## One LED block for all colors! Simplify design and lower inventory cost

### Harmony XB4/XB5

#### Simplified design

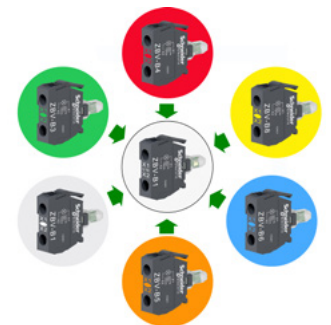
A unique and universal white LED block replaces 6 individually-colored blocks of the Harmony XB4/XB5 offering simplifying product placement during design.

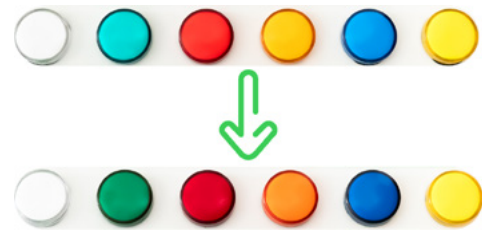
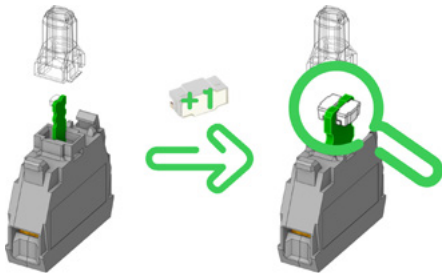
New design moves from 6 colored LED blocks to one universal white LED block with 2 side LEDs instead of 1.

New saturated colored plastic used on all heads except white and yellow.
